Subject: Submittal of Replacement Pages to Update the NAC-UMS® FSAR from Revision 3 to Revision 4 (Docket No. 72-1015)

10 CFR 72.48 Evaluation Summary Report

NAC-UMS® Universal Storage System
(Docket No. 72-1015)

DETAIL G–G (SH 3 / AB)
OPTIONAL CONFIGURATION

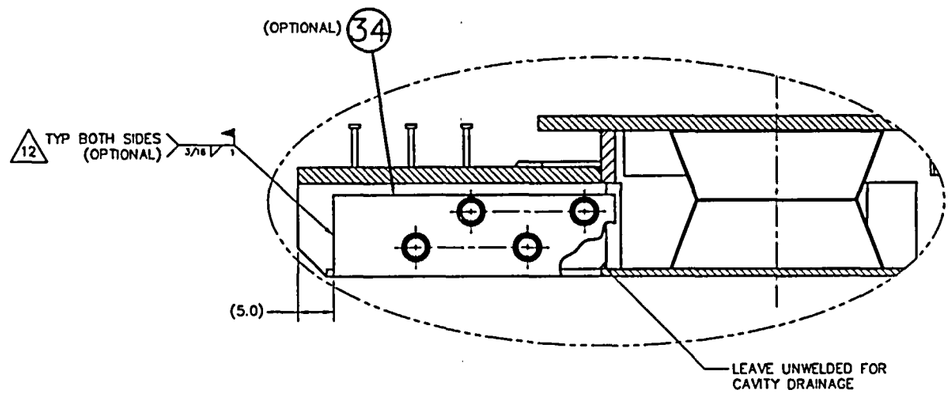
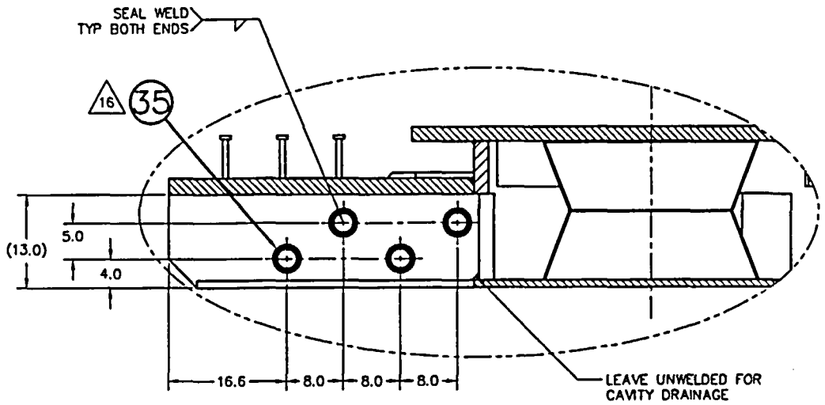
14. Revises Item 13 (Inlet Side) to add an optional chamfer.
15. Adds a leader callout in Detail G-G (Optional Configuration) Sheet 4, Zone A4 pointing to the new optional chamfer to read: "Leave unwelded for cavity drainage". Revises graphics to show correct pictorial view of Item 13 against Item 15.

16. Adds a leader callout in Detail G-G (Optional Configuration) Sheet 4, Zone C2 pointing to the new optional chamfer to read: "Leave unwelded for cavity drainage". Shows a cut-away from the optional Item 34 in the area of the new optional chamfer to place the new leader callout

PROJECT	DRAWING	REV
790	575	10
SCALE 1/1	SH 1 OF 2	9-22-04

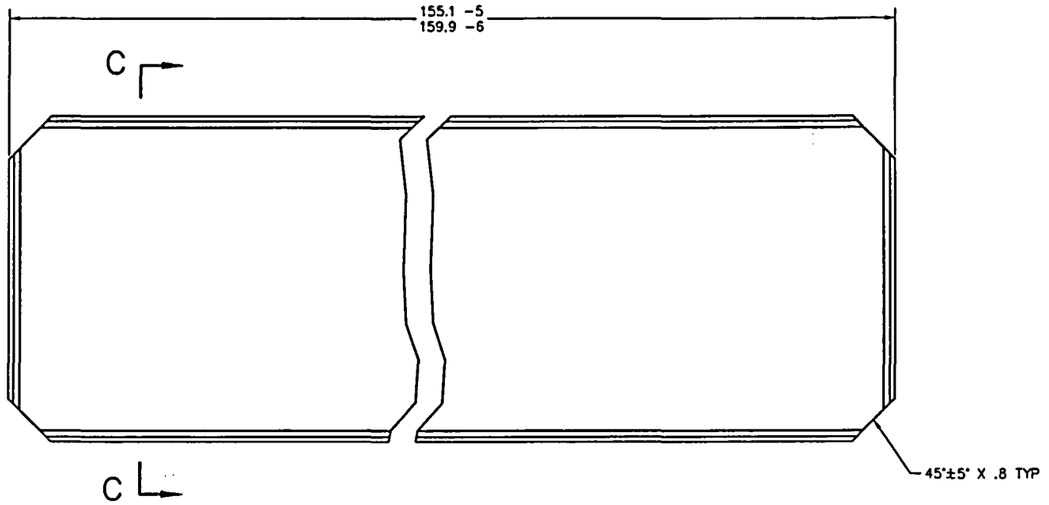
Revision 10 of Drawing 790-575 changes the BOM Items 3 & 4 material callout: IS) Boral WAS) Boral/Metamic.

PROJECT	790	DRAWING	581	REV 9
SCALE FULL	WEIGHT	SH 1 OF 2		S. SHAW 9-22-2004

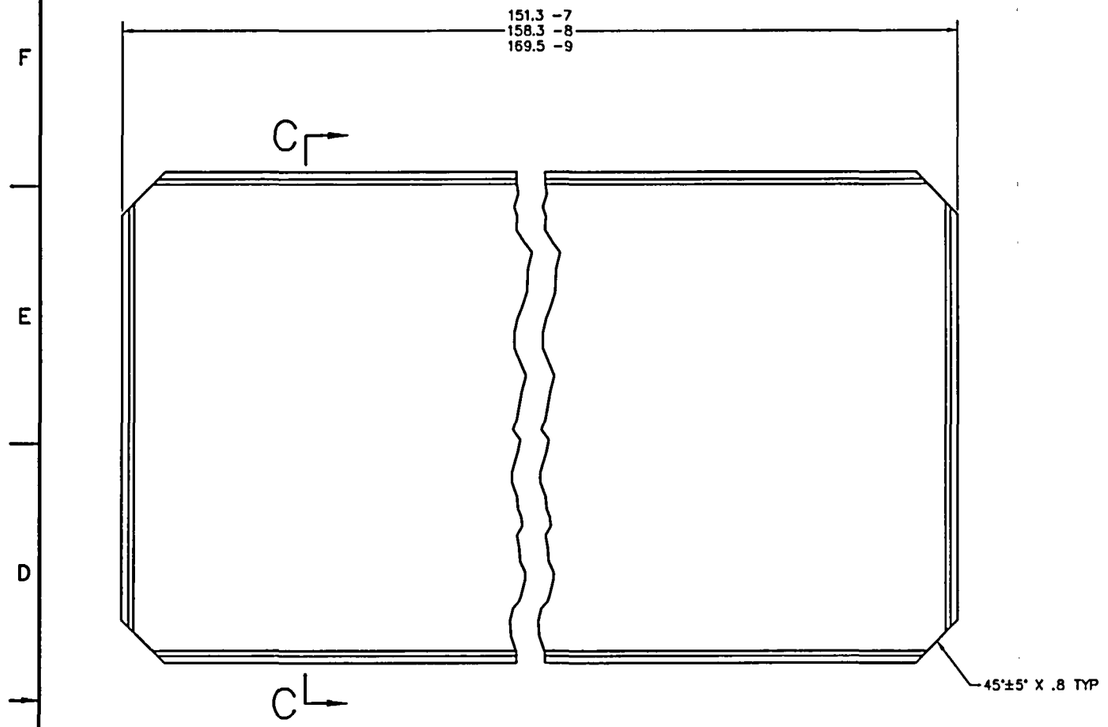
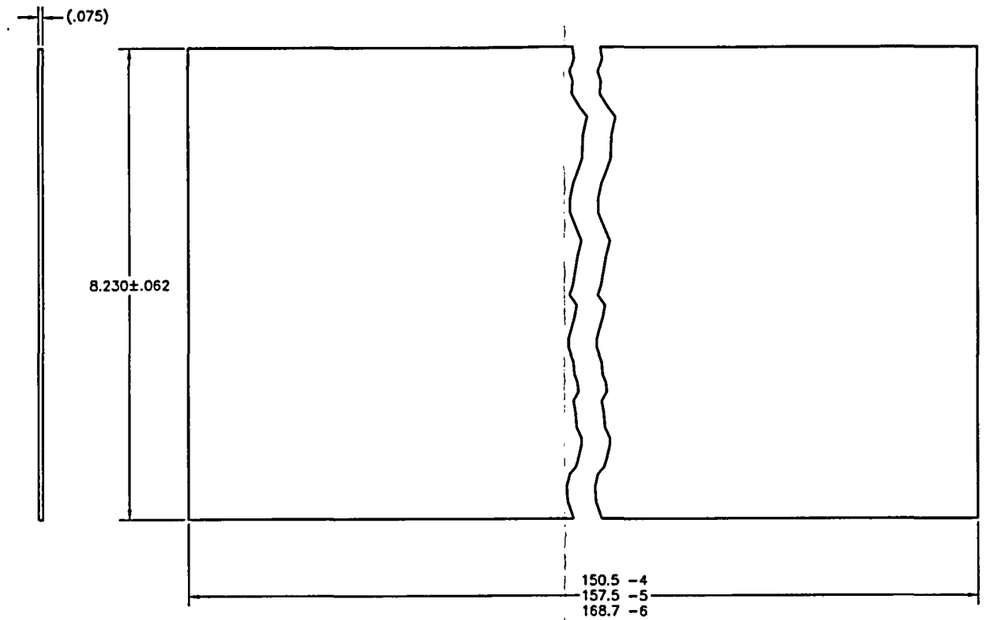
Revision 9 of Drawing 790-581 changes the dimension of Sht 2 of 2, Zone B6: IS) 8.29 MIN. WAS) 8.3 MIN. & changes the BOM Items 3 & 4 material callout: IS) Boral WAS) Boral/Metamic.

PROJECT	790	DRAWING	605	REV 11
SCALE 1/1	WEIGHT	SH 1 OF 2	9-27-2004

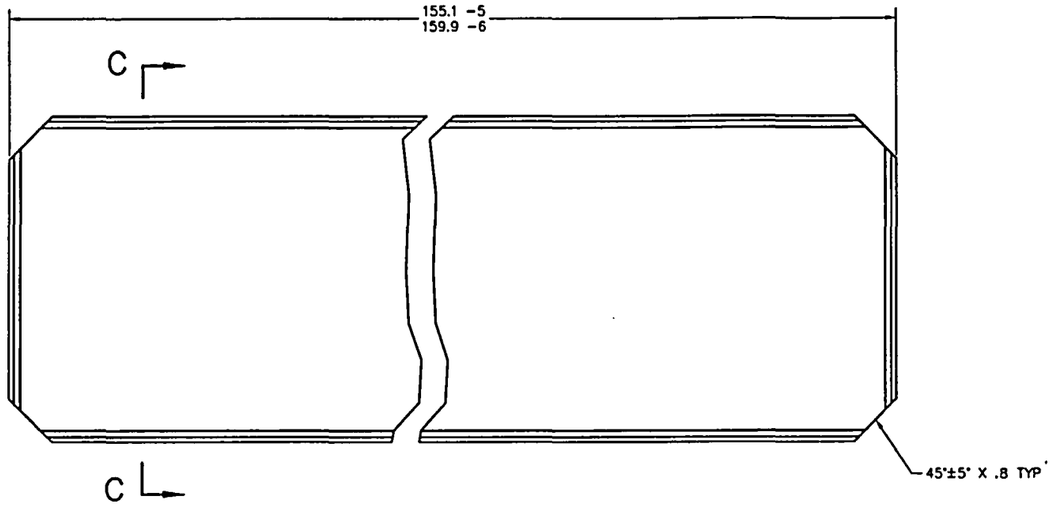
Revision 11 of Drawing 790-605 changes the BOM Items 3 & 4 material callout: IS) Boral WAS) Boral/Metamic.

PROJECT 790 | DRAWING 617 | REV 3 | SH 1 OF 2

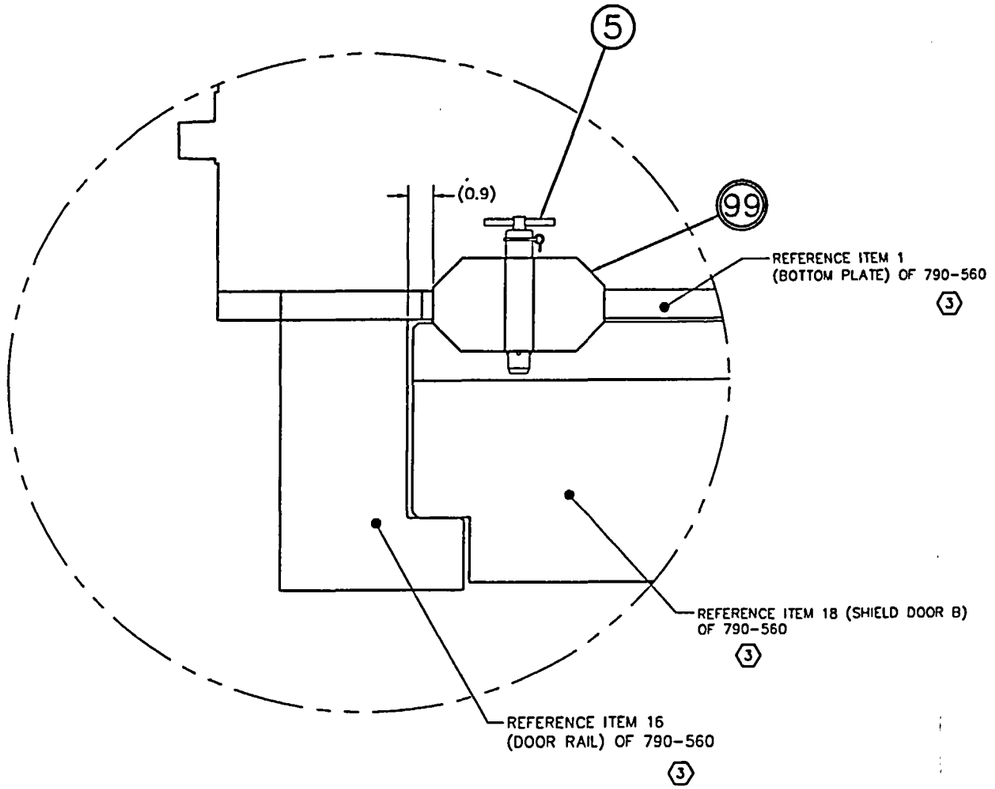
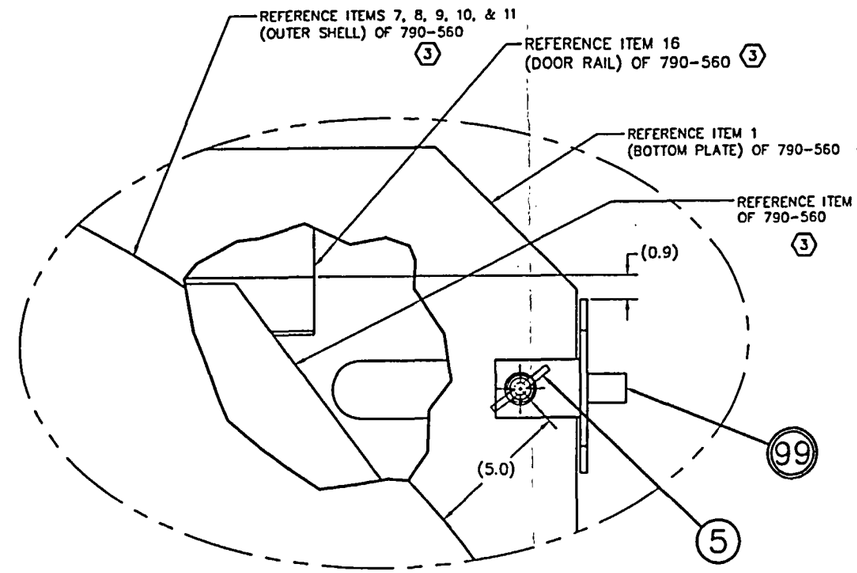
Revision 3 of Drawing 790-617 changes the dimension leader callout, Sht 2 of 2, 7 places: IS) 790-560, WAS) 790-060.

Figure 3.4.2-1 Universal Storage System Welded Canister Closure

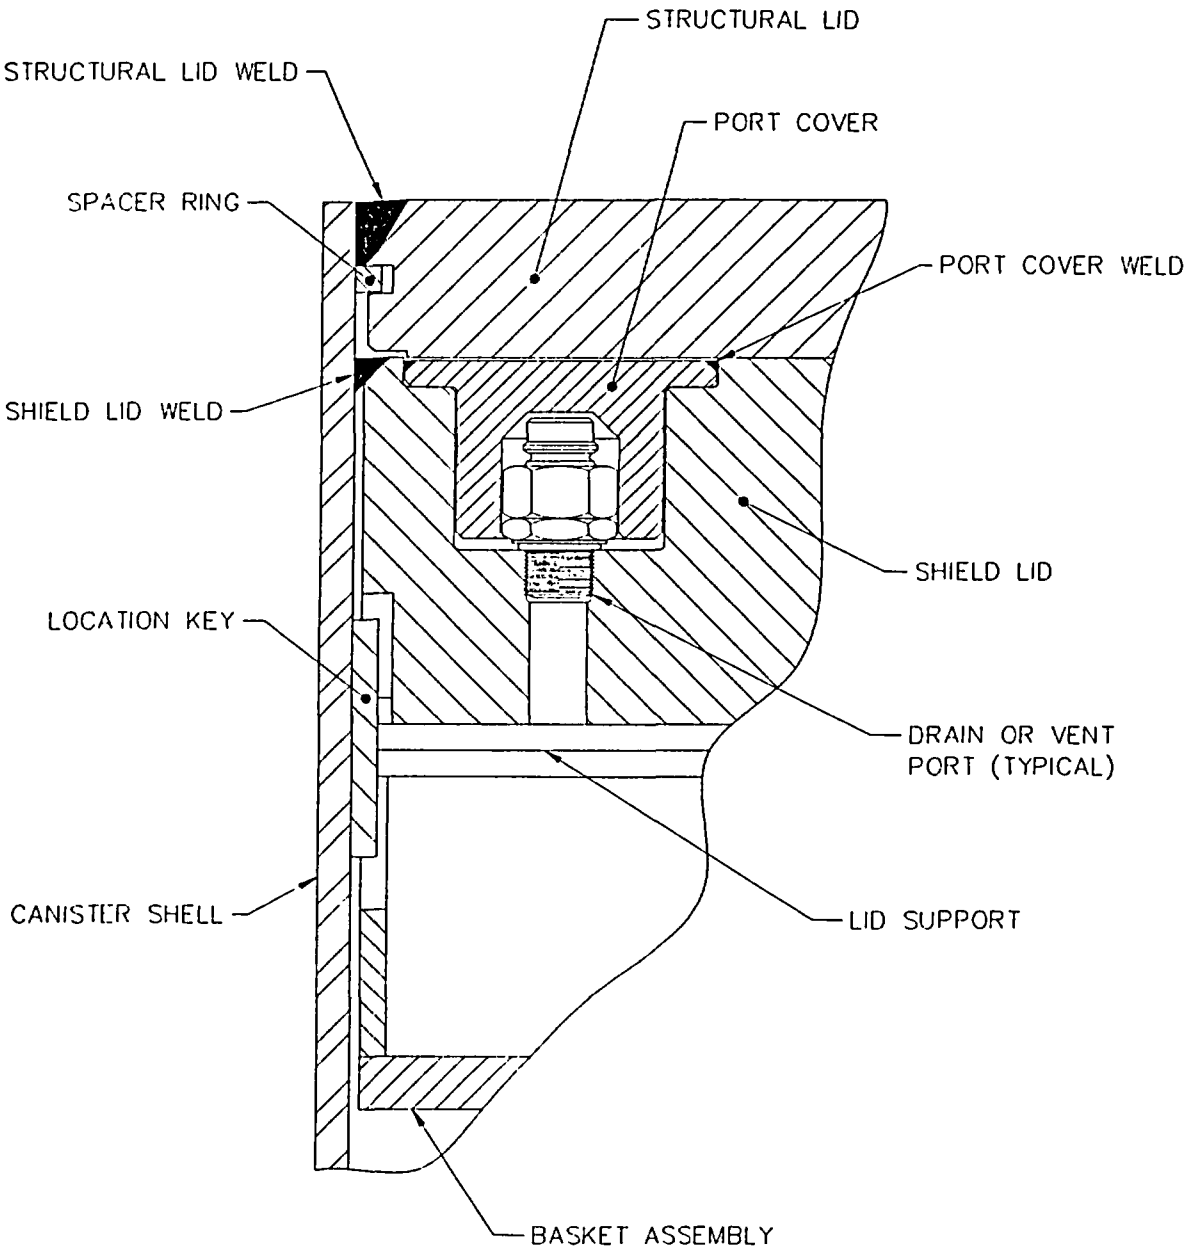
Chapter 3, Page 3.4.2-1 (Figure 3.4.2-1); Chapter 7, pages 7.1-3, 7.1-5, 7.1-8 (Figure 7.1-2) & 7.5-1; Chapter 12, pages 12C3-9, 12C3-12, 12C3-13, 12C3-16, 12C3-19, 12C3-20, 12C3-22 & 12C3-24.

Figure 4.4.1.3-2 Three-Dimensional Transfer Cask and Canister Model - BWR

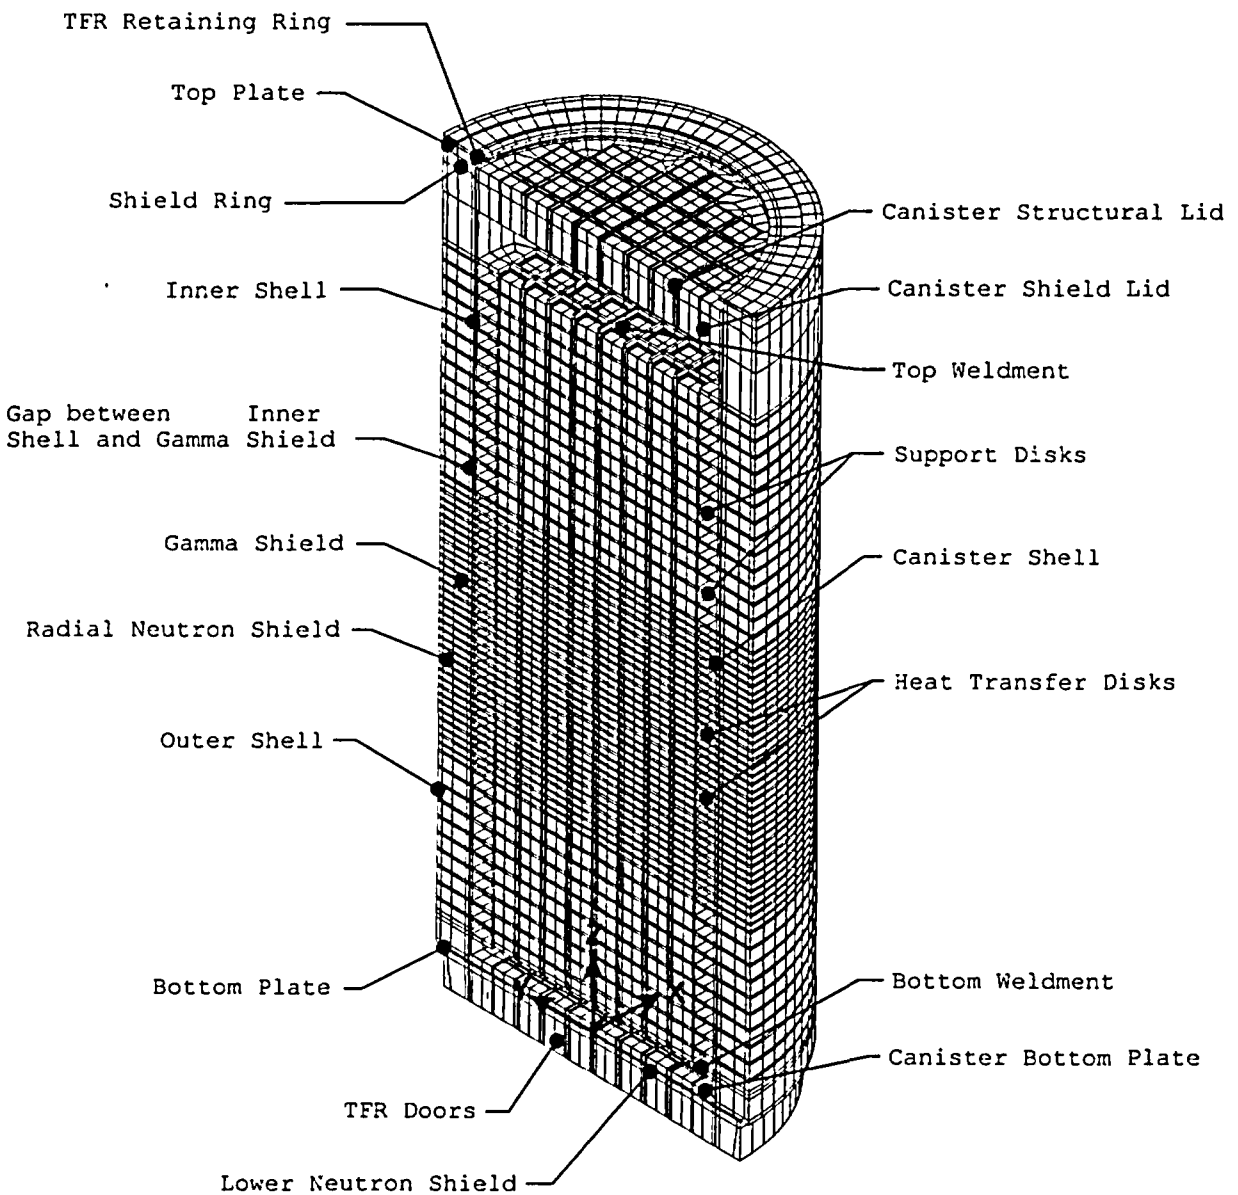
Revises Chapter 4, Sections 4.4.1 & 4.4.3, to add saturated steam to the media considered in the thermal analysis for transfer conditions.

Page 4.4.1-27	72.48/DCR(L) 790-FSAR-3A	Section 4.4.1.3, 2nd paragraph – added sentences 5 & 6
Page 4.4.1-28	72.48/DCR(L) 790-FSAR-3A	1st full paragraph, 1st & 2nd sentences – revised throughout
Page 4.4.1-30, Figure 4.4.1.3-2	72.48/DCR(L) 790-FSAR-3I	Text box – deleted "(water/helium)"

Figure 4.4.1.6-1 Two-Dimensional Fuel Tube Model: PWR Fuel

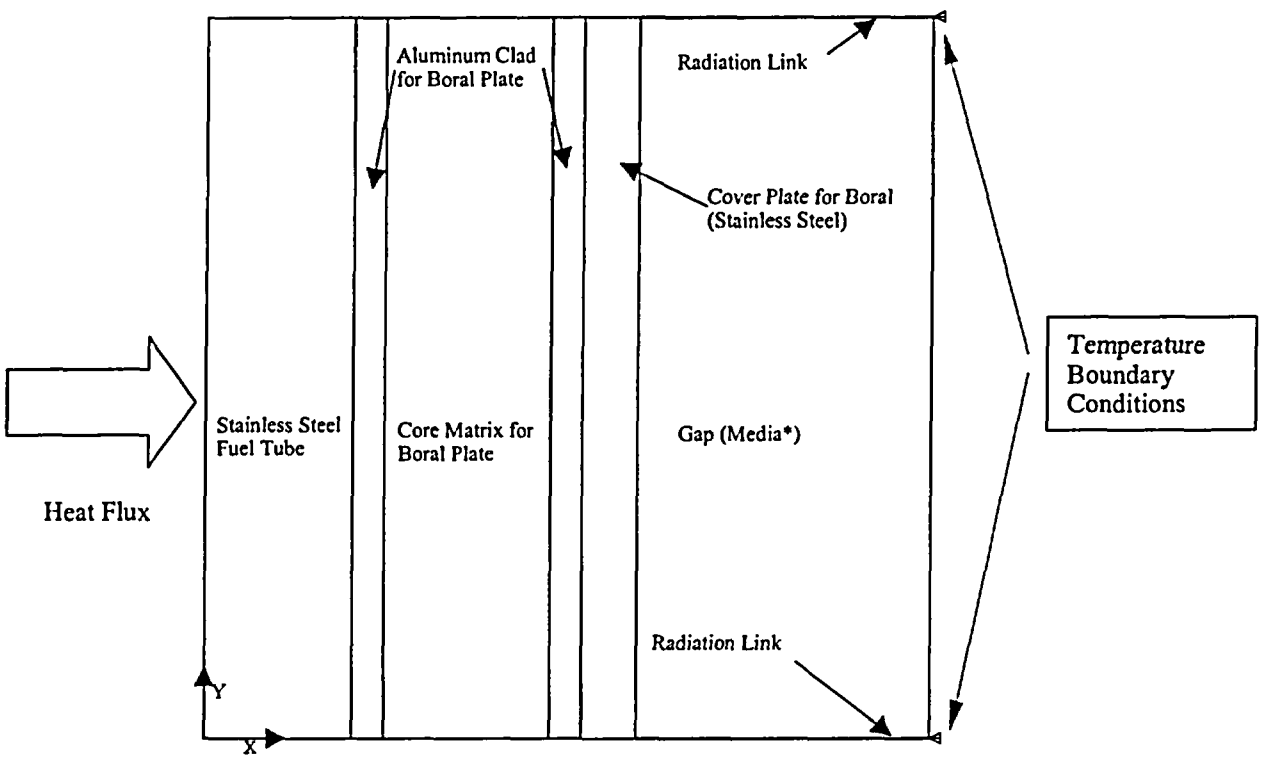
Chapter 4, pages 4.4.1-2, 4.4.1-30 (Figure 4.4.1.3-2) 4.4.1-35, 4.4.1-38, 4.4.1-41 (Figure 4.4.1.6-1), 4.4.1-42 (Figure 4.4.1.6-2), 4.4.1-43 (Figure 4.4.1.6-3), & Section 4.4.3 (page 4.4.3-1).

*Media can be water, vacuum, helium or saturated steam.
